UNITED STATES PATENT AND TRADEMARK OFFICE

Office Action Summary	Application No. 10/523,504	Applicant(s) UNGEMACH ET AL.	
	Examiner Kari Petrik	Art Unit 3743

DETAILED ACTION

FIG. 1A

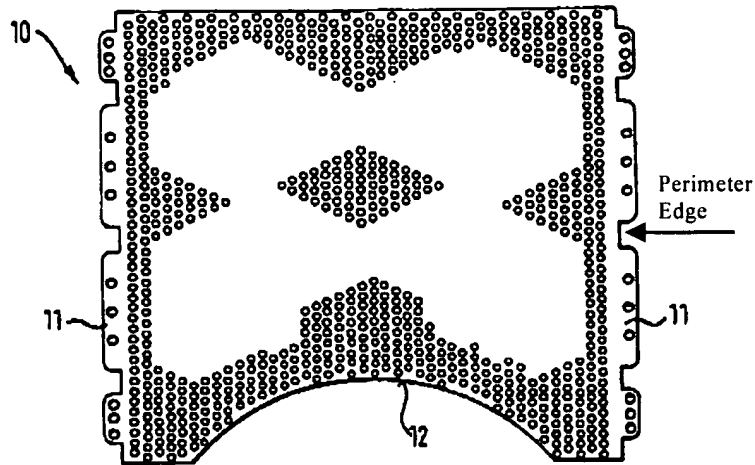
6. Regarding claims 1 and 10, Vilsmeier et al disclose a patient restraint member comprising an integral, one-piece sheet of thermoplastic material (10) having spaced apart groups of perforations and solid bands extending between the groups of

perforations and extending at least partially across the sheet (Figure 1A). The sheet has a perimeter edge (see Figure below) lying in a common plane and is free of additional strips of material (sheet 10 itself is free of additional strips and is capable of being used alone to restrain the user). Vilsmeier et al discloses a generally planar frame (31) arranged to be attached to and extending around a portion of the perimeter edge of the sheet and being coplanar with the perimeter edge. Vilsmeier does not disclose that the frame is U-shaped.

7. Regarding claims 2-8 and 11-16, Vilsmeier et al discloses a thermoplastic sheet (10) having groups of perforations and solid bands extending across the sheet between the groups of perforations to provide rigidity (Figure 1A). The solid bands criss-cross the sheet and intersect at a location spaced inwardly from the edge. Vilsmeier et al also discloses a thermoplastic sheet having a non-perforated edge (the arrow in Figure 1A below is considered a non-perforated edge). Vilsmeier et al do not disclose that the solid bands extend completely across the sheet, and do not disclose that they extend in a perpendicular or non-perpendicular angle from the perimeter edge.

However, a thorough reading of the specification provides no criticality to the arrangement of the bands. Specifically, Applicant has not disclosed that having bands that extend from the perimeter edge at a perpendicular angle or non-perpendicular angle provides an advantage over bands extending through the sheet at any other angle.

9. The Applicant argues that the Examiner's interpretation of Figure 1A is incorrect in that the non-perforated areas shown are merely a drawing convention so that the draftsman need not draw the holes across the entire area of the sheet. The Examiner spoke with Joshua Chase at the USPTO Drafting Review Branch who stated that this is not a drawing convention, and that the figure does show a sheet having a perforated area and a non-perforated area.
